Picton High School Redevelopment (Mod 1)

*State Significant
Development
Modification Assessment
(SSD 8640 MOD 1)
June 2019*

Figure 4 | Approved and proposed special education building (source: Section 4.55 Modification Application, 2019)

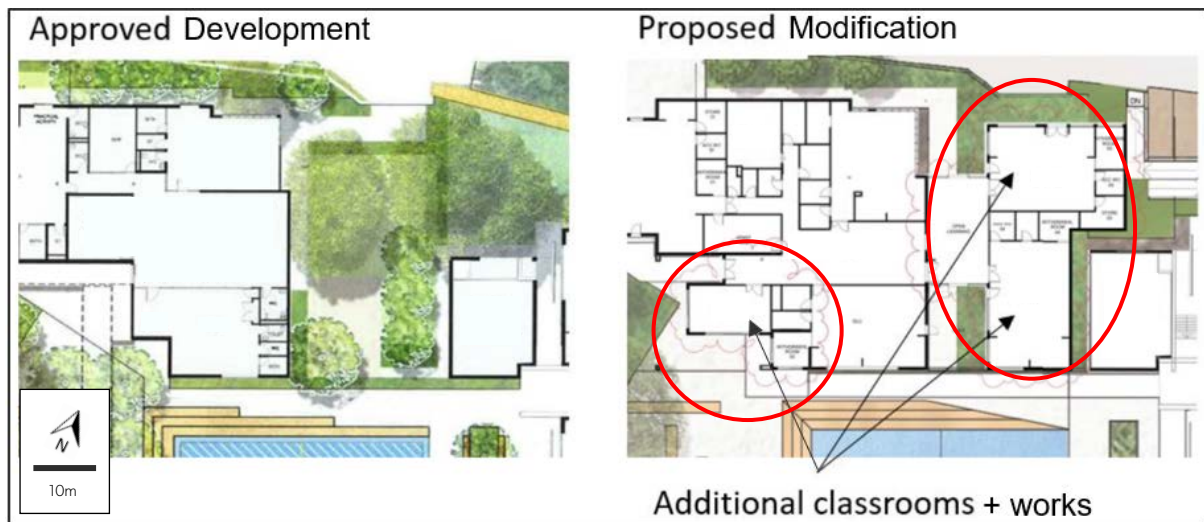
The proposal involves construction of two additional support unit classrooms to the north of the main building between the existing Block N and existing Block J, on the site of the former Block K building (see **Figure 4**). The additional classrooms would be an extension of the existing special education building. The new building extension would be one storey in height.

The Applicant states that the classrooms are required to accommodate additional support units. Specialist support unit classrooms require greater floor space than typical classrooms. The Applicant states that the additional support units proposed under this application would not result in an increase in student or staff numbers.

Figure 5 | Proposed and approved tree removal (source: Section 4.55 Modification Application, 2019)

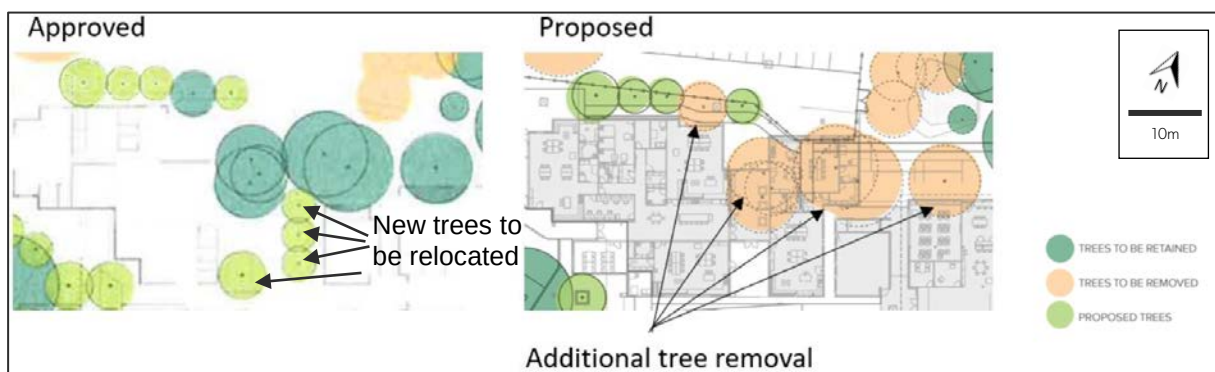
The modification also proposes the removal of seven trees, six of which are to facilitate the two additional support classrooms (see **Figure 5**). Furthermore, four trees that were proposed to be planted in this area are being relocated elsewhere on the site. The seventh tree (numbered 66) is located on the southern side of the main building (see **Figure 22**) and is proposed to be removed following further consideration of the construction impacts of the redevelopment.

Figure 6 | Proposed and approved main building height (source: Section 4.55 Modification Application, 2019)

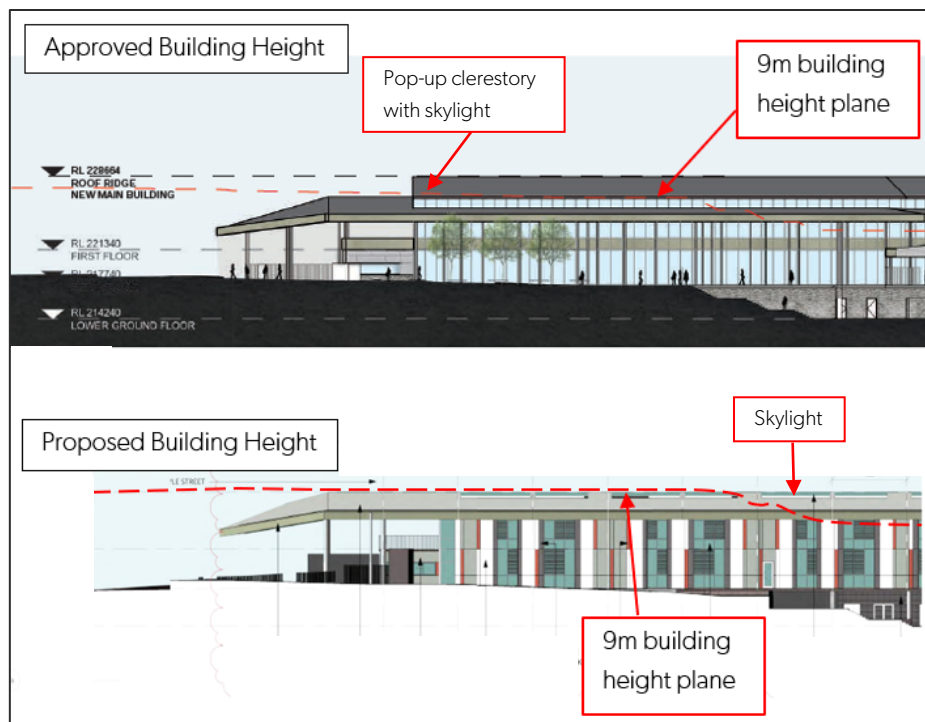
The design of the approved main building is proposed to be amended to reduce the overall width and height of the roof, replacement of pop-up clerestory with skylight, reduction in width of floorplate, installation of solar panels on the roof and amendments to the southern façade to remove some glazed panel sections.

Figure 11 | Reconfiguration of southern car park (source: Section 4.55 Modification Application, 2019)

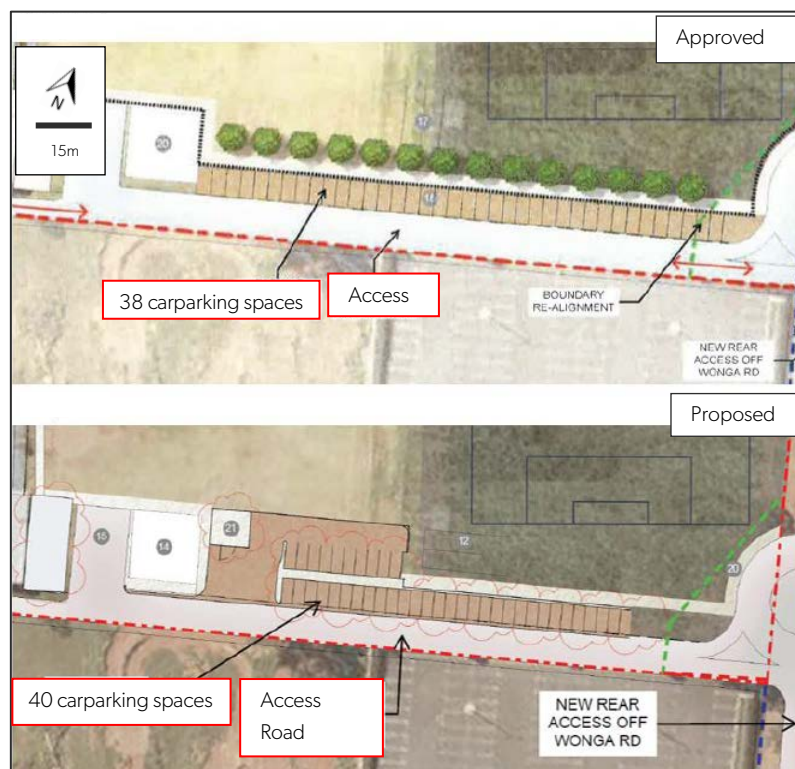
The application proposes reconfiguration of both the northern and southern parking areas (**Figures 11 and 12**). The Applicant states that the reconfiguration of the southern boundary car park is required due to the amendments of the waste collection location. The Application states that the reconfiguration of the northern boundary car park is necessary due to the requirements to install fire pump equipment in a fully enclosed and ventilated room near available water infrastructure. The Applicant also noted that the installation of the fire pump equipment is not part of this modification. A separate planning pathway would be carried out for this installation.

The reconfiguration of the parking areas would not result in a change in the number of parking spaces provided, which would remain 141 spaces (including 4 accessible parking spaces). However, two of these car parking spaces are proposed to be moved from the northern to the southern car park as part of the reconfiguration.

Figure 13 | Proposed and approved building height (source: Section 4.55 Modification Application, 2019)

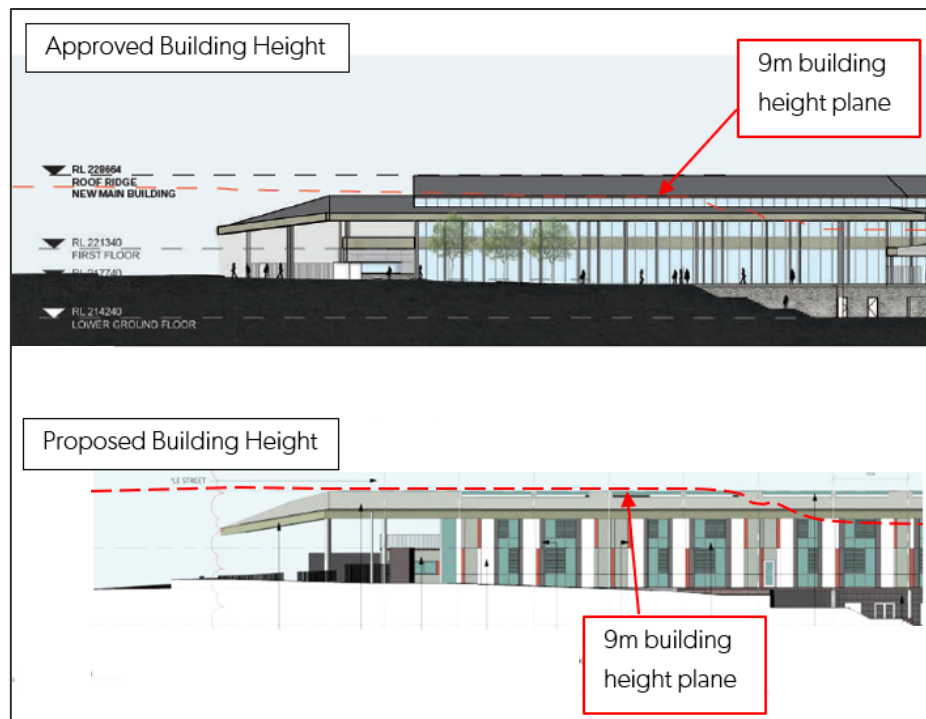
The proposed modification would result in a maximum building height of 9.66m, a reduction from 14.42m which was approved under the original application (**Figure 13**). Notwithstanding, the modification exceeds the maximum building height control of 9m in the WLEP 2011. The original application included a Clause 4.6 variation request which the Department considered in its assessment of the building height. The proposed modification has considered the merits of the proposal and the impacts of the height variation on the surrounding area in assessing whether the built form is appropriate for the site.

The Applicant states that whilst the revised main building (STE(a)M) exceeds the maximum building height control under WLEP 2011, the building results in reduced height than that approved under the original application. Furthermore, the Applicant states that the exceedance of the building height was justified by a Clause 4.6 variation request under the original application and was well founded.

The Department notes that reduced building height to the main building is due to the removal of the pop-up clerestory with skylight. The proposed modification would generally maintain the approved building envelope and would not generate any unacceptable environmental impacts with respect to view loss, overshadowing or privacy to the adjoining and nearby landowners. The proposed modification would also maintain the visual relationship between the proposal and the existing character of the area. The Department considers that the proposed building height of the main building would result in a better visual outcome than the one approved under the original application.

Figure 22 | Trees proposed to be removed (source: Section 4.55 Modification Application, 2019)

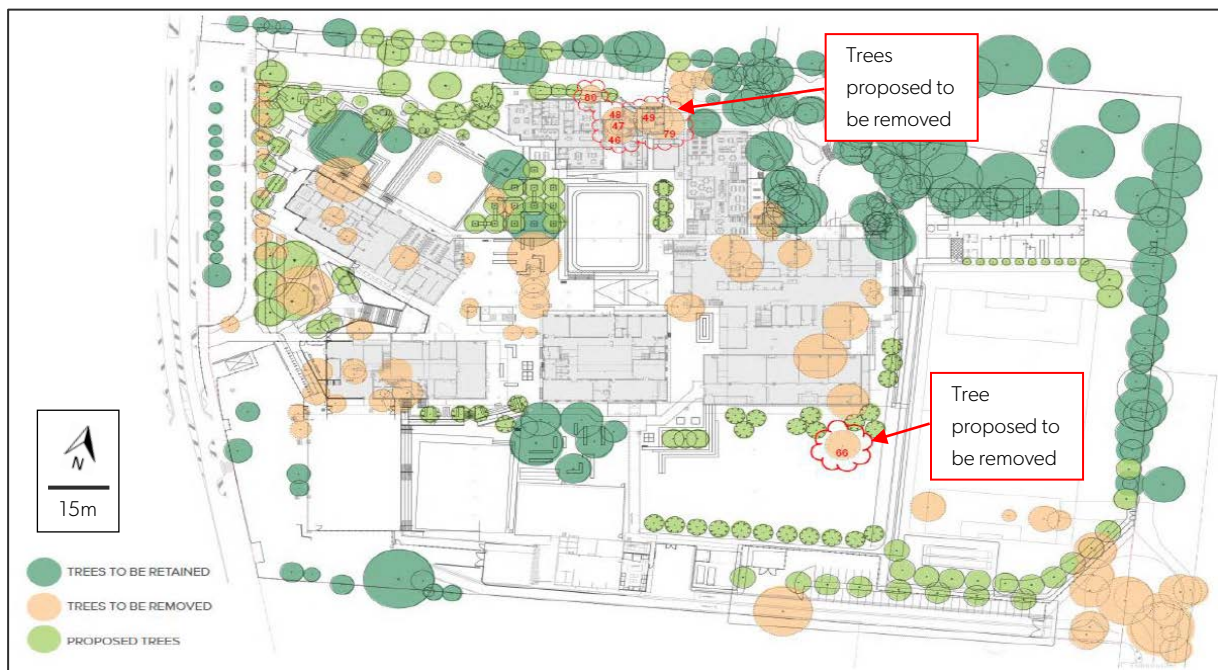
The proposed modification involves the removal of seven trees (numbered 46, 47, 48, 49, 66, 79 and 80) from the site (**Figure 22**). The Applicant states that the removal of six of these (46-49 and 79-80) is required to facilitate the proposed two additional support classrooms and tree 66 is proposed to be removed following further consideration of the construction impacts of the previously approved redevelopment.

The Applicant submitted an Arboricultural Assessment report addendum prepared by Horticultural Management Services which identifies that the six trees proposed to be removed for the support classrooms have a low level of significance. It also identifies that tree 66, a Southern Blue Gum is considered to be in fair health, and of low to moderate significance. Council raised no concern with the removal of these trees. The Department acknowledges that accommodation of the proposed building works forms an integral part of the proposed land use. Therefore, the removal of seven additional trees from the site is unavoidable to facilitate the development. The Department also notes that these trees will be replaced with compensatory trees.

The modification would result in a total of 99 trees being removed for the redevelopment, and a total of 116 trees compensatory trees proposed as shown in **Figure 22**. This is an increase of 38 compensatory trees. Condition C22 Tree Protection and D36 Landscaping are proposed to be amended to include the reference to the addendum to Arboricultural Assessment report and revised landscaping plans to reflect the proposed changes.

The Department is satisfied with the proposed modification subject to the recommended amendments to the conditions of consent.
